Application by National Highways
for Order Granting Development
Consent for the Lower Thames
Crossing

DEADLINE 6

Comments on Applicant's
Submissions at D5

on behalf of DPWLG

1.1.2 DPWLG's response noted that Slide 31 of 9.96 Visual Representation of A13- A1089-LTC [REP4-207] was misleading in terms of movements to Tilbury. For ease of reference, an extract of Slide 31 is provided below:

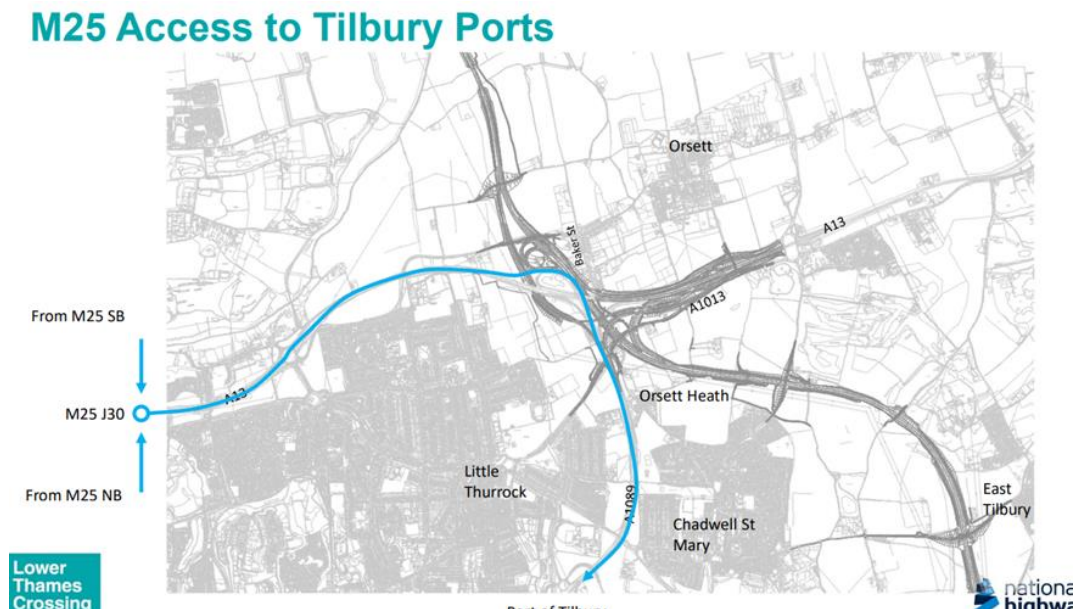
1.1.4 'it is wrong to say (as suggested on Slide 31) that movements will use the M25 J30 to reach Tilbury. As shown at Table 8.29 – 8.31 of the TA Appendix C (Transport Forecasting Package), shows that 9% of all movements on the LTC will be routing to A1089'.

- 1.1.6 DPWLG wish to highlight that the Applicant's comments at Deadline 5 regarding Tilbury movements (as shown on Slide 31) are not reflective of their oral submissions made at ISH3. In this respect, the transcript of ISH3 records that Dr Wright (on behalf of the Applicant) stated the following:

'In terms of routes into Port of Tilbury, obviously there is this route that could use Orsett Cock roundabout, but our traffic modelling indicates that actually, it's not a preferred route and the preferred route would continue to be to use the M25 and junction 30 and the A13, taking advantage of the reduced traffic on those routes'. (ISH3 Transcript, Page 59)

- 1.1.7 Whilst the Applicant's oral representations at ISH3 are not in direct conflict with their D5 response, they indicate that the response (or the visual representation it refers to) is misleading. DPWLG, therefore, wish to flag this to the ExA.

'The Applicant would make the following comments on the response provided by DPWLG to this question. Slide 31 of 9.96 Visual Representation of A13-A1089-LTC [REP4-207] does not suggest that movements will use M25 junction 30 to reach Tilbury. The slide simply provides the route by which traffic from M25 junction 30 can reach Tilbury once the Project opens'.
